ALERT SERVICE BULLETIN

NO. 412-09-133

SUBJECT: INSPECTION/CHANGE OF RESTRAINT SYSTEM ASSEMBLY WITH INERTIA REEL AND MANUAL LOCK HANDLE

SERVICE BULLETIN NUMBER 501836-25-01 ISSUE 1

Figure 1 – Serial Number and Date Code Information

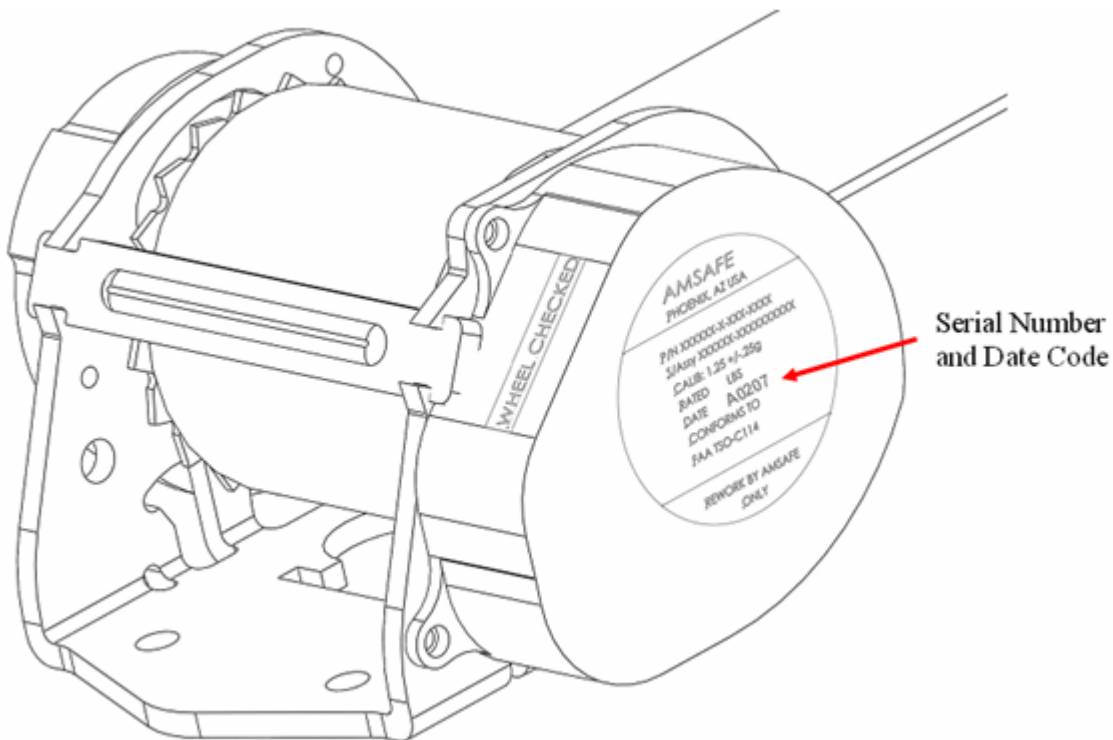
1. The inspection of the restraint system does not require the restraint system to be removed from the seat.
2. Date Code Inspection. The date code can be found on the inertia reel identification label see Figure 1. For access to the inertia reel identification label please refer to the applicable seat manufactures instruction defined in their CMM.

If the date code is prior to 1 Feb 07 (X0207) or after 30 Nov 08 (X1108) no further action is required.

Figure 2 – Wheel Checked Label

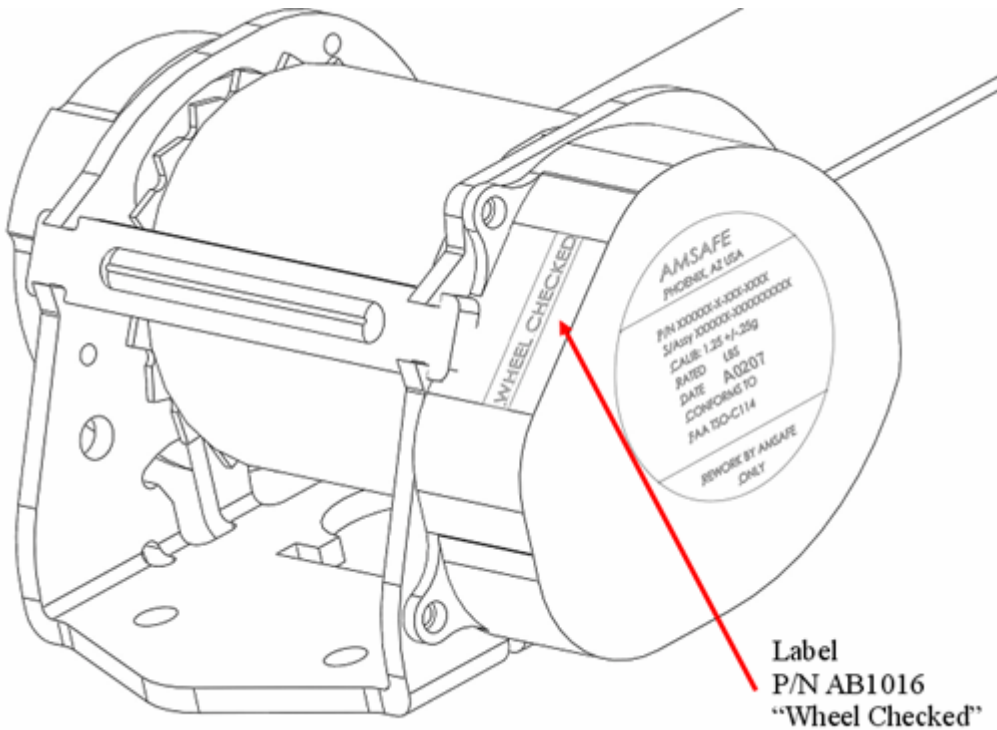
If the serial number is between 1 Feb 07 (X0207) and 30 Nov 08 (X1108), and the inertia reel does not include a label attached by AmSafe stating "Wheel Checked" (Figure 2) continue to step 3.
